CHANGES TO THE SPECIFICATIONS

CHANGES TO THE PLANS

REVISIONS
STEVEN M. CLOUSE WRC
PRIMARY CLARIFIER
REHABILITATION
PRIMARY CLARIFIER
PLAN AND SECTION

MAP NO.	SHEET
SECT. NO.	D-03
DR. EG	CK. JG
JOB NO. 21-0111	9 OF 28

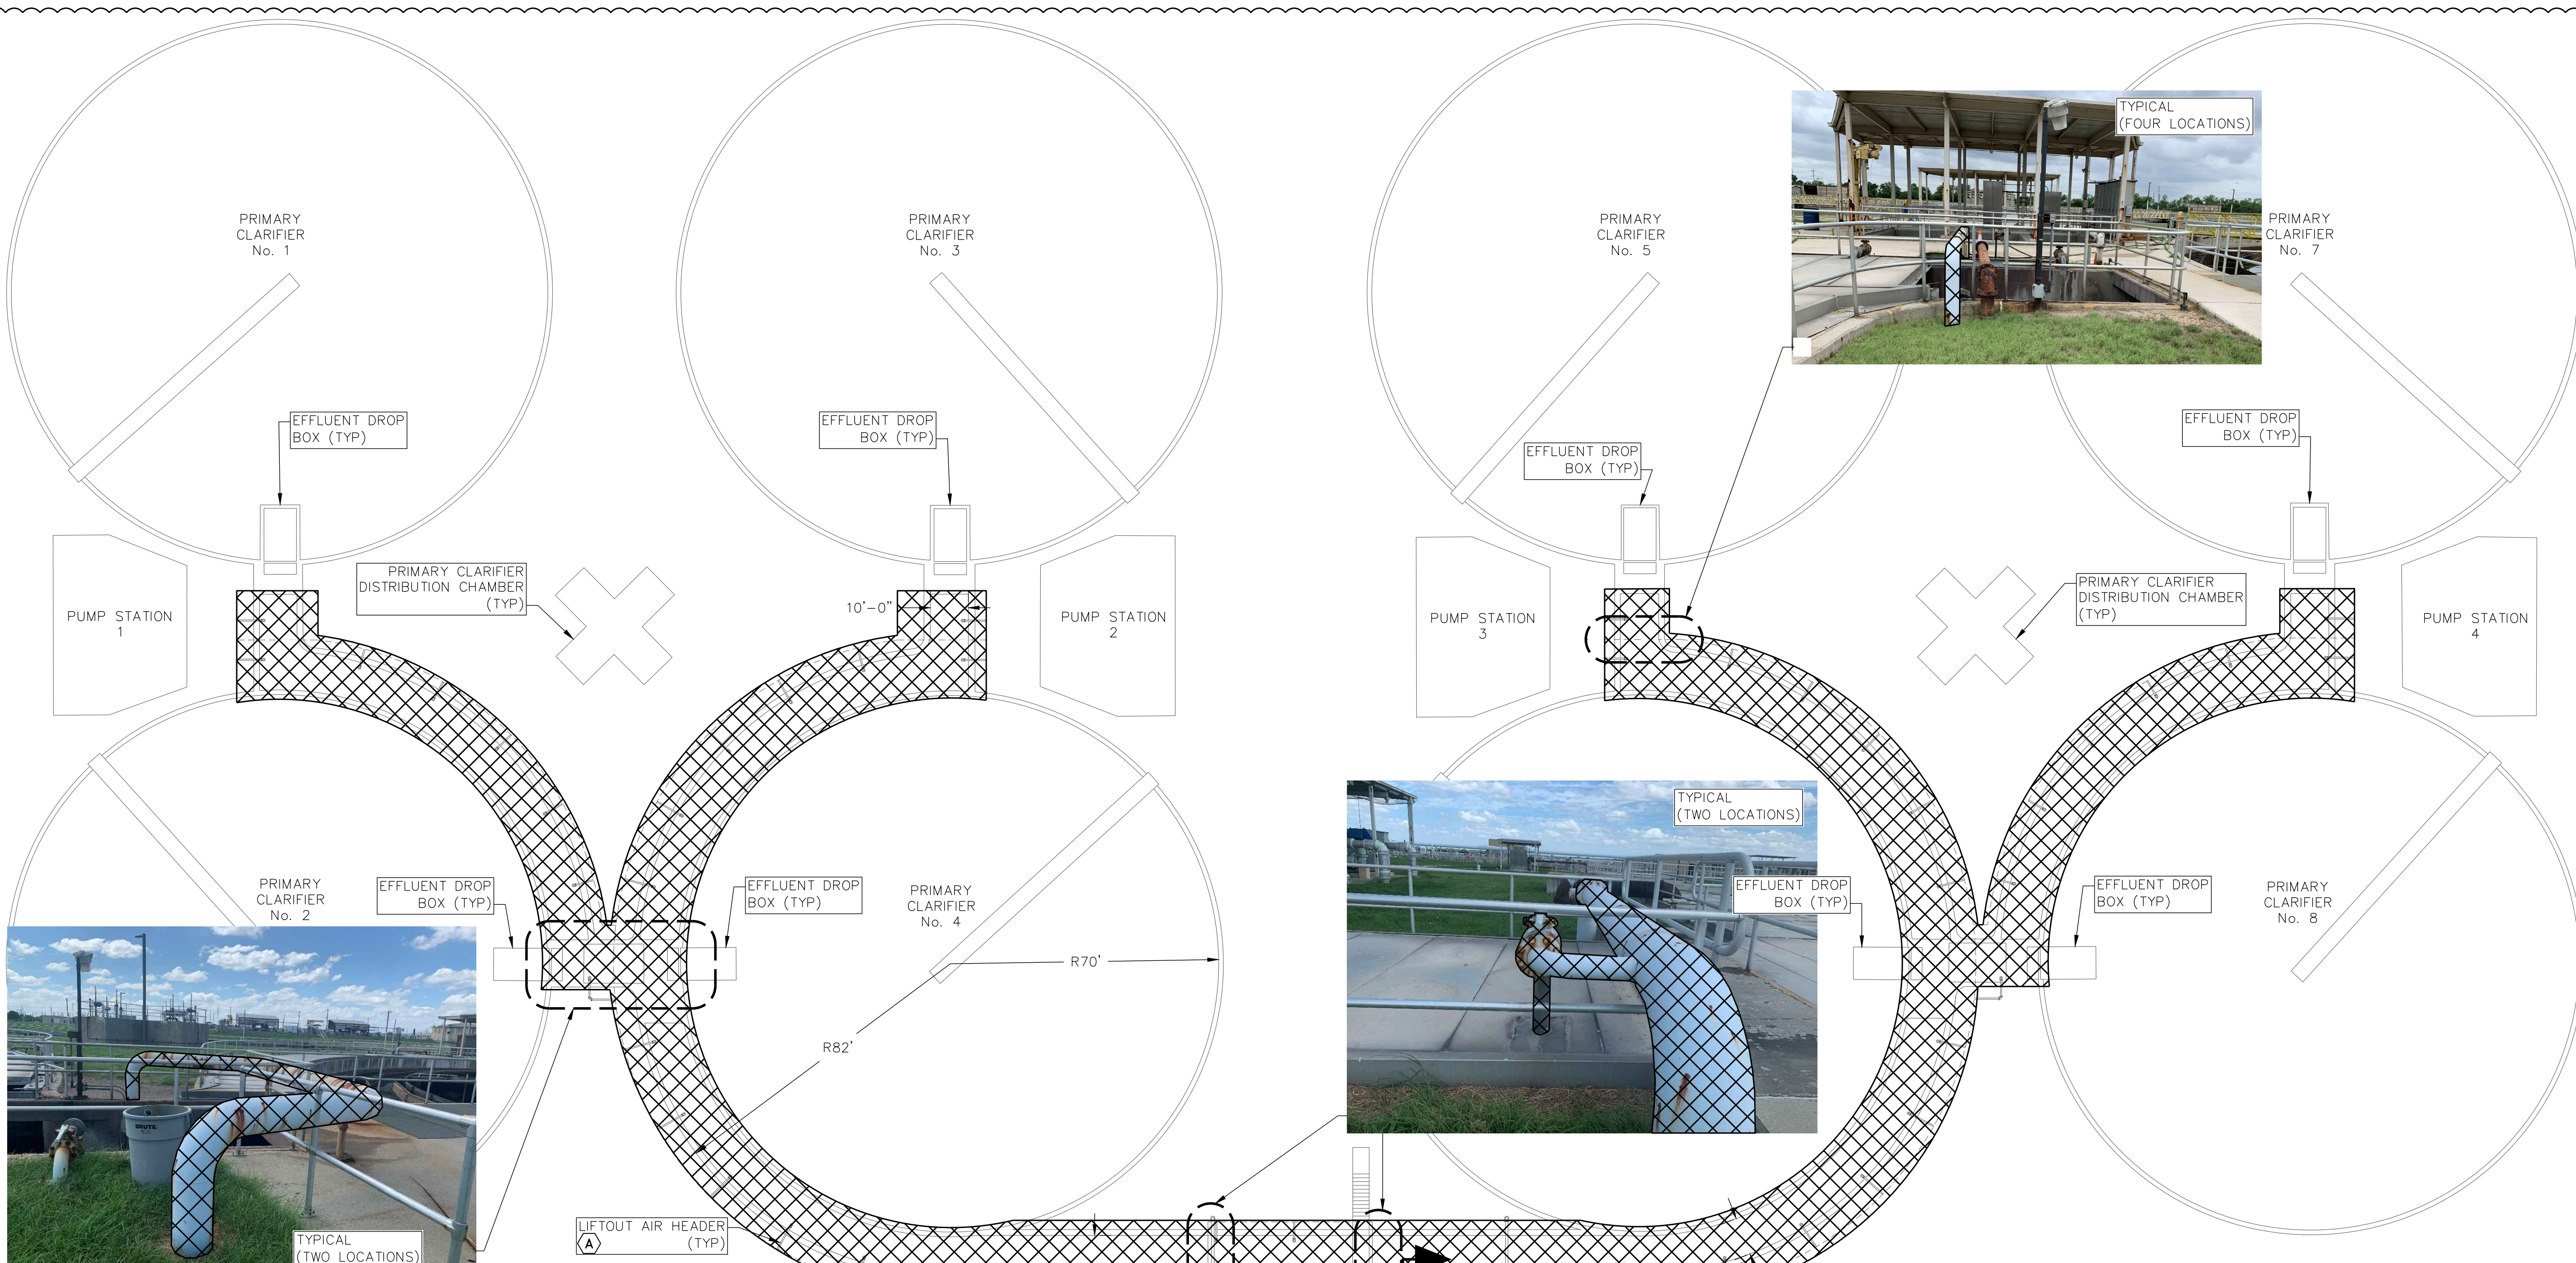
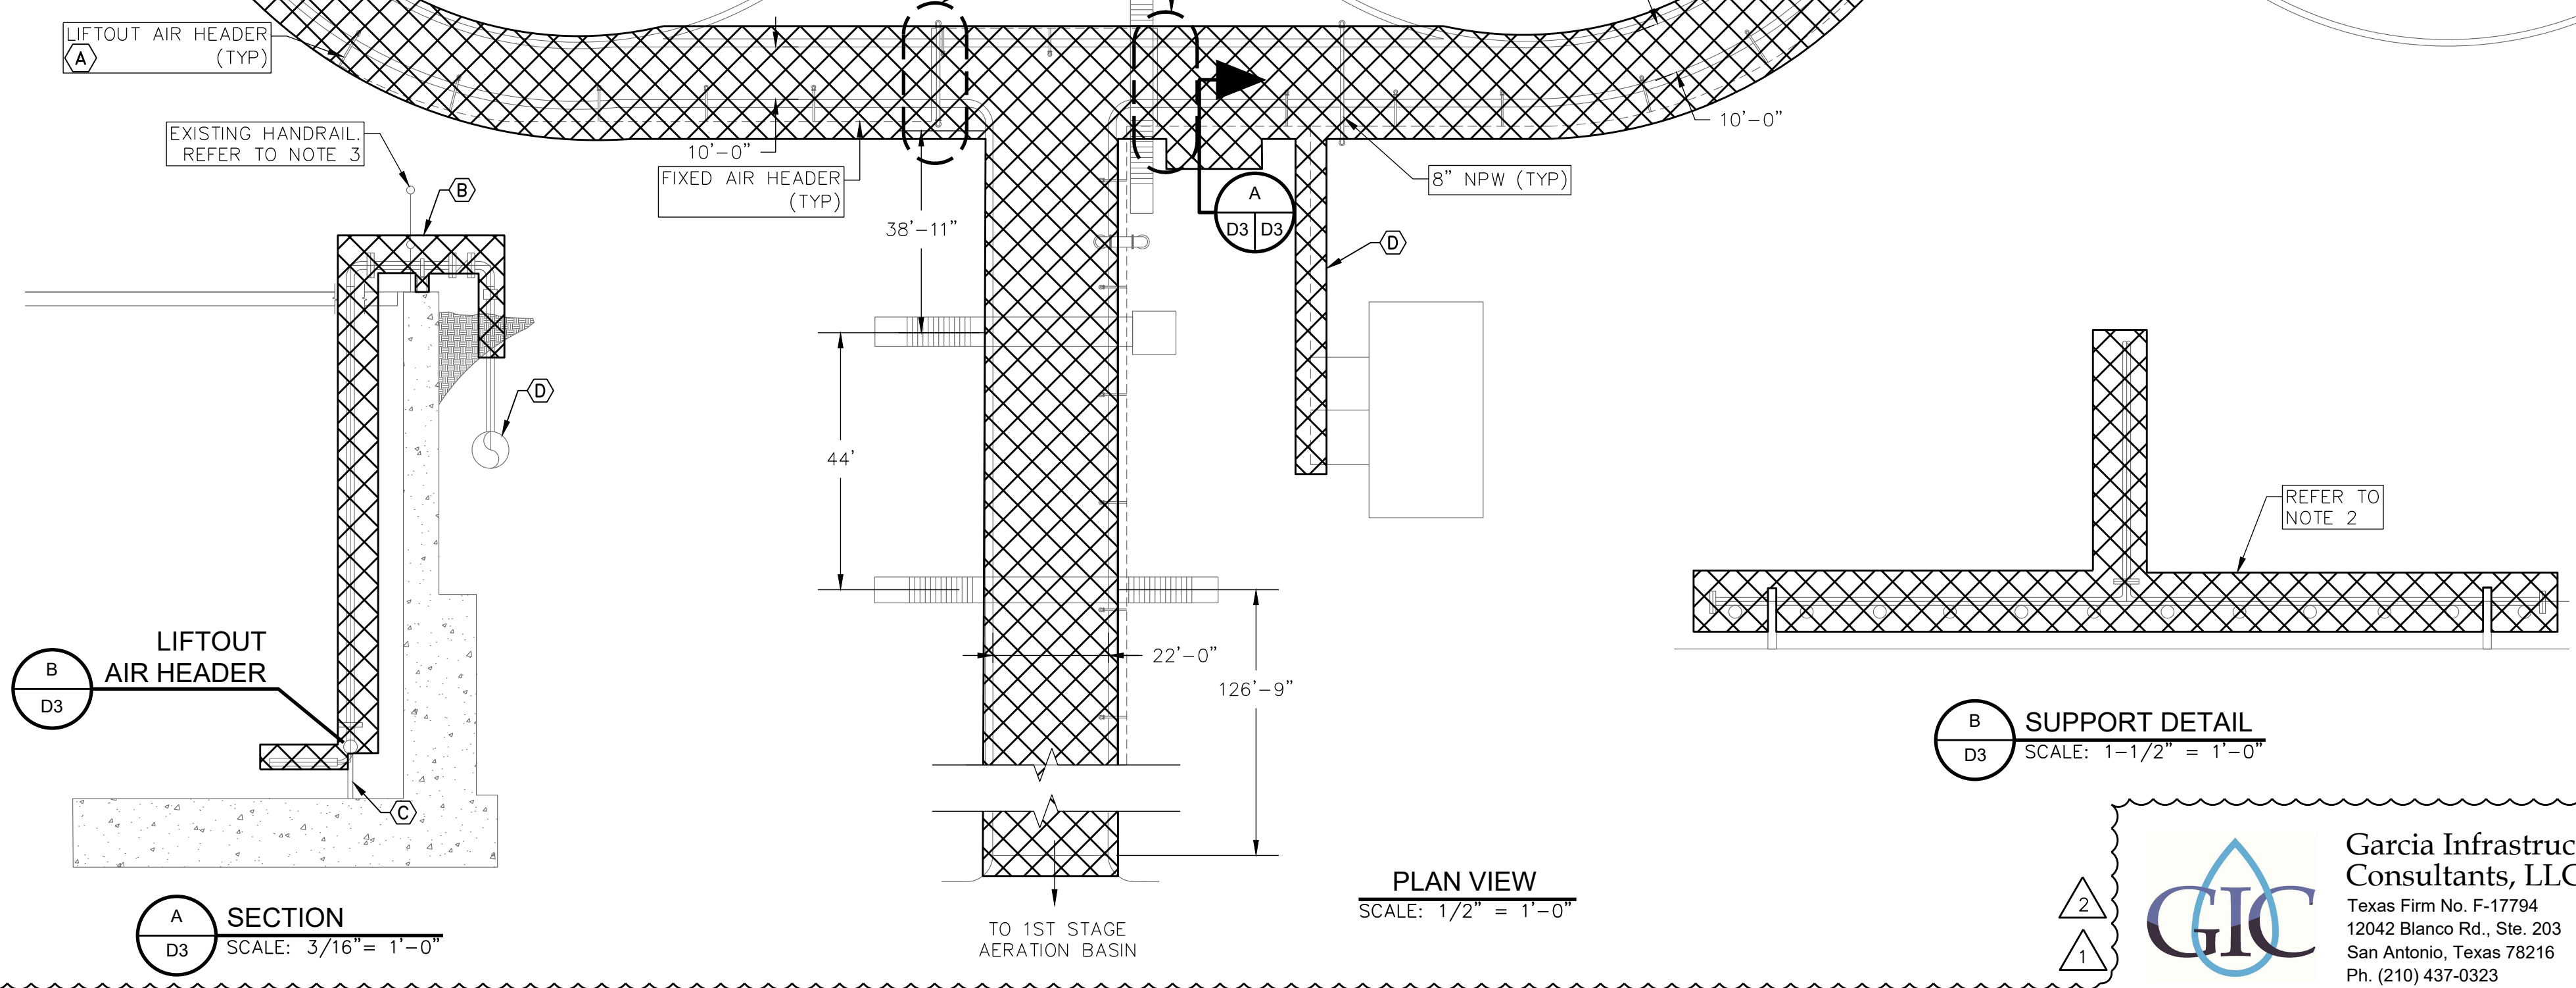
8. Reference plan sheet S-02 – upper left. Are 2 each, 10” flap valves (for a total of 16 each) to be replaced in all, eight drop boxes shown on plan sheet D-03? (Plan sheet D-03 only has four drop boxes called out.)

Response: Each Primary Clarifier includes a single drop box, total of eight (8) drop boxes. Sheet D-03 was revised to identify all eight (8) drop boxes. Two (2) 10-inch Flap Valves are required on each Primary Clarifiers No. 1 to 5, and 8. A total of twelve (12) 10-inch Flap Valves are required for the six (6) Primary Clarifiers. New flap valves are not required on Primary Clarifier No. 6 and 7.

SHEET M-06 21 OF 28

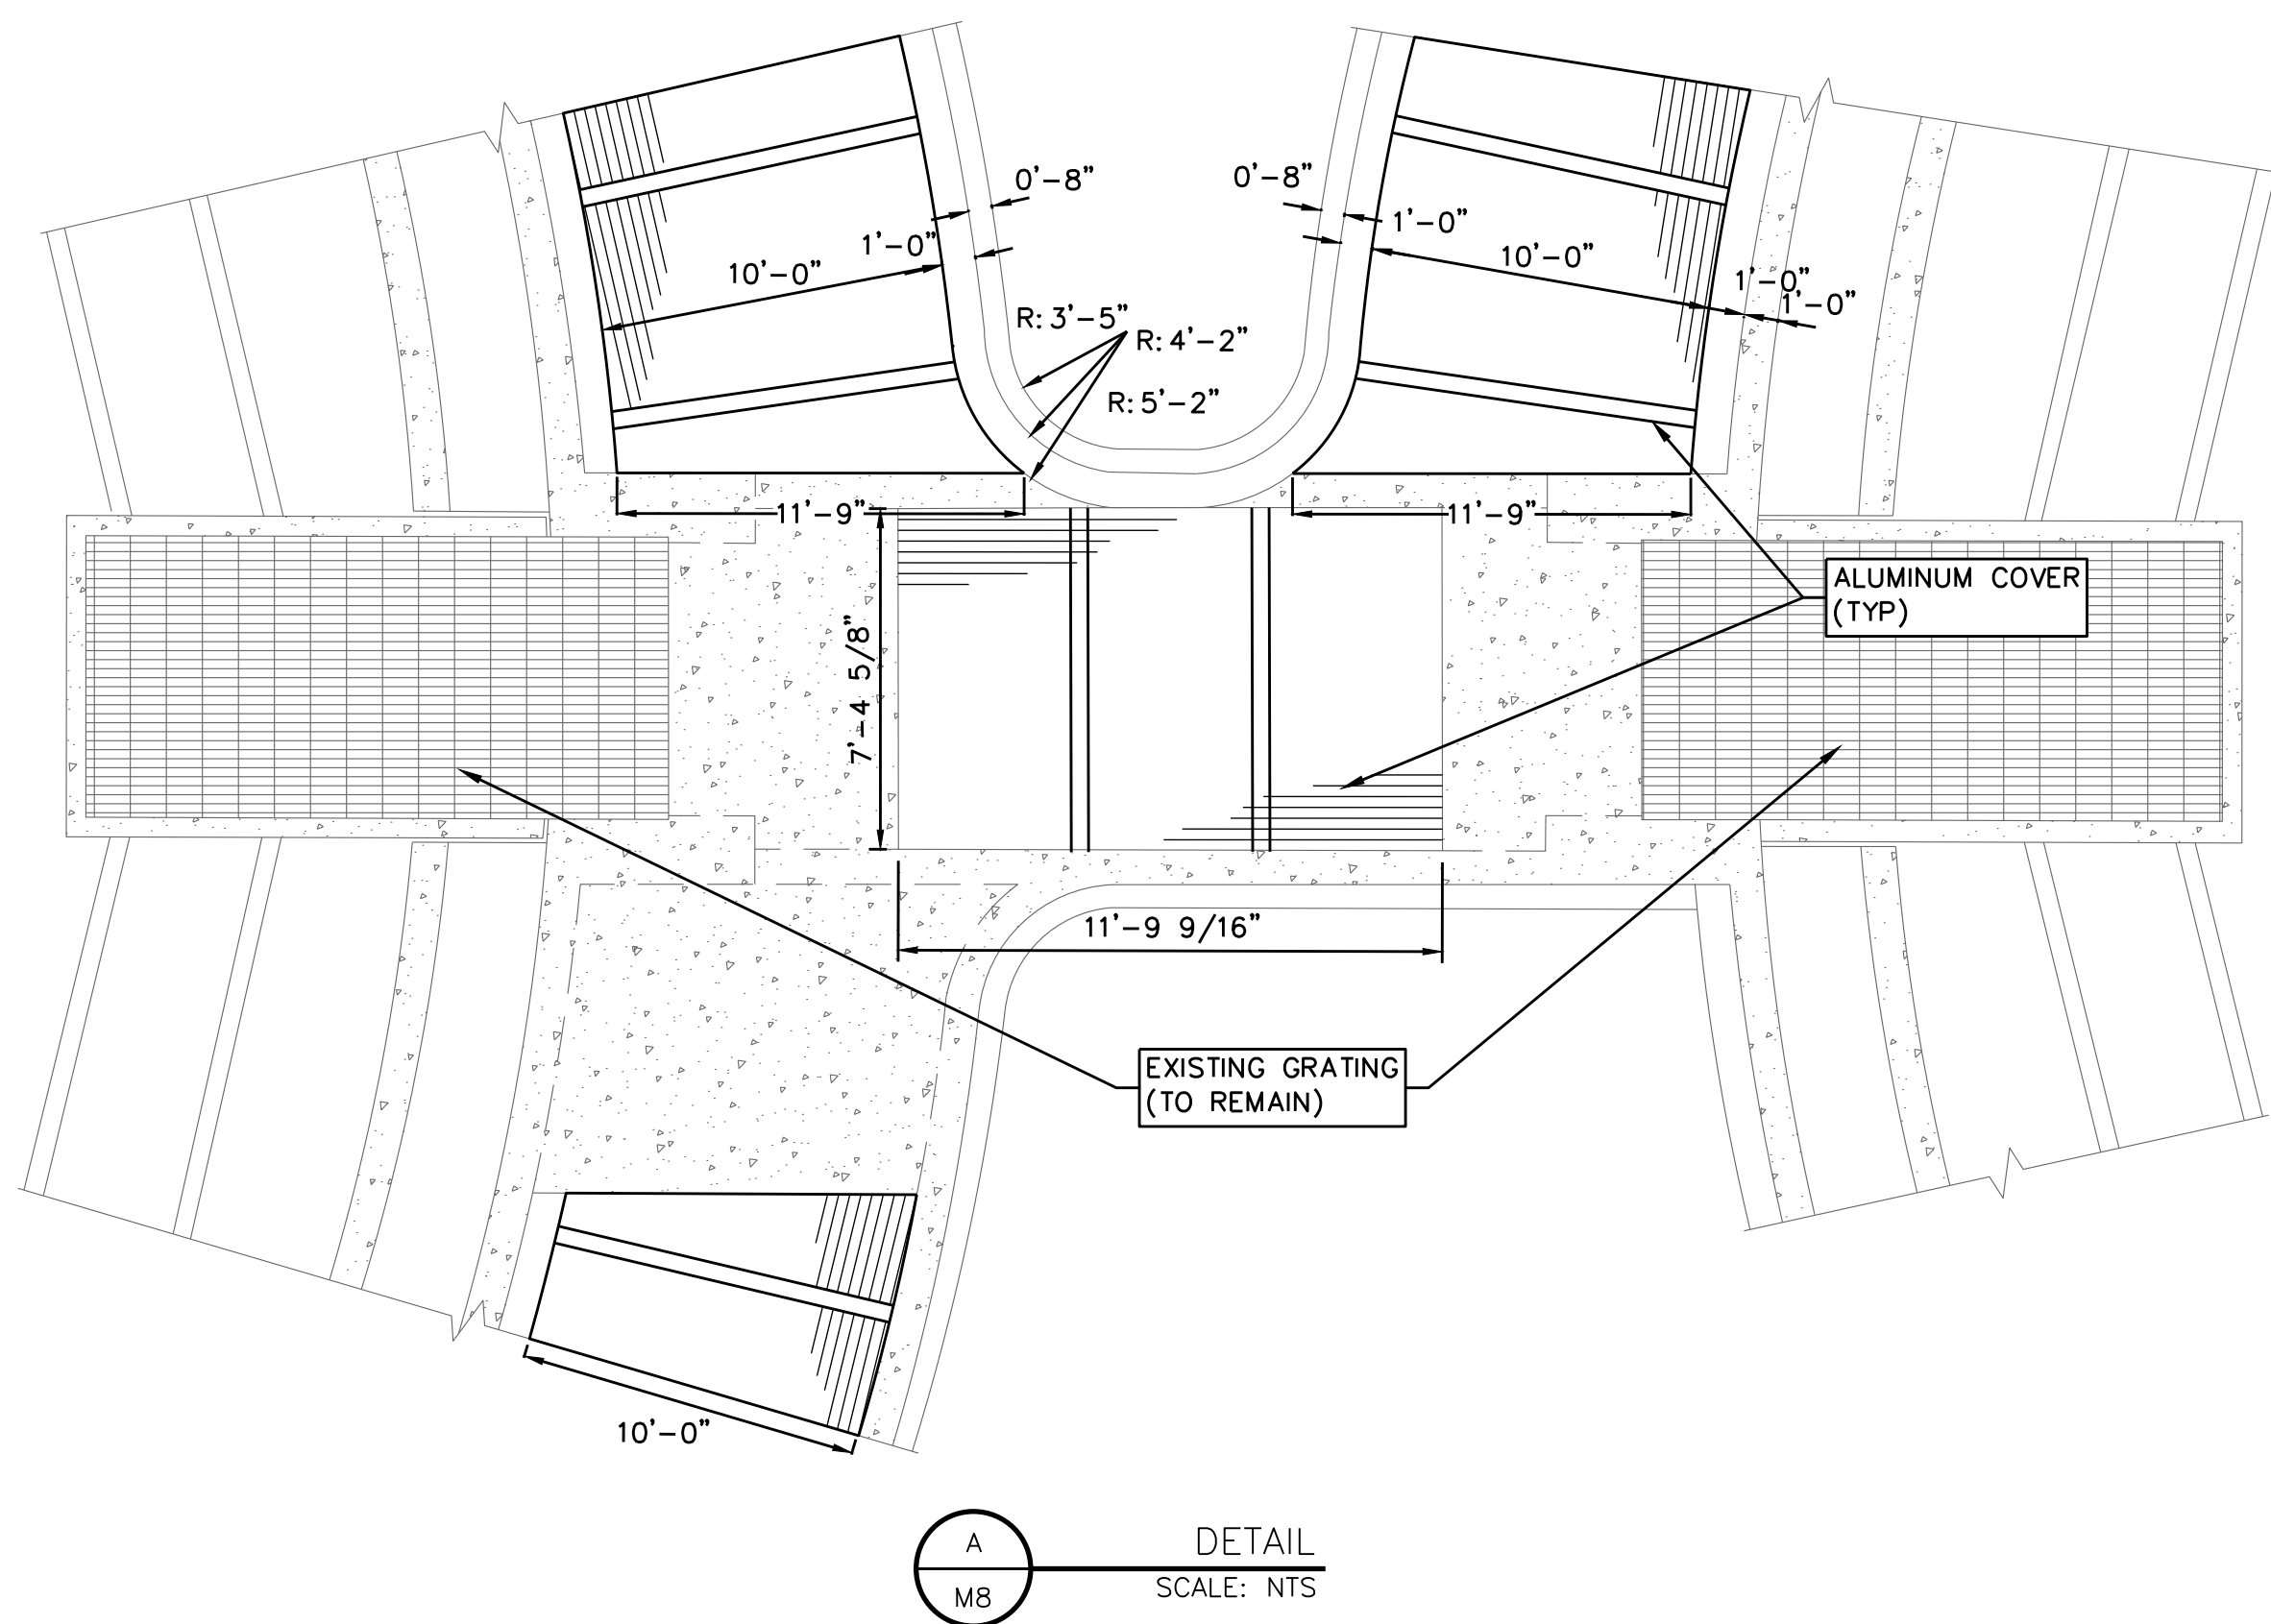
9. Plan sheet M-06 – middle right states the butterfly valves are to be stainless steel. However, spec 40 23 43 – page 4 – number 2 at the top states they are to be carbon steel. Please, clarify.

Response: The 4-inch isolation valves shall be Butterfly Style and 316-Stainless Steel. The larger valves are cast iron. Sheet M-06 and Specification Section 40 23 43, Paragraph 2.3 was modified.
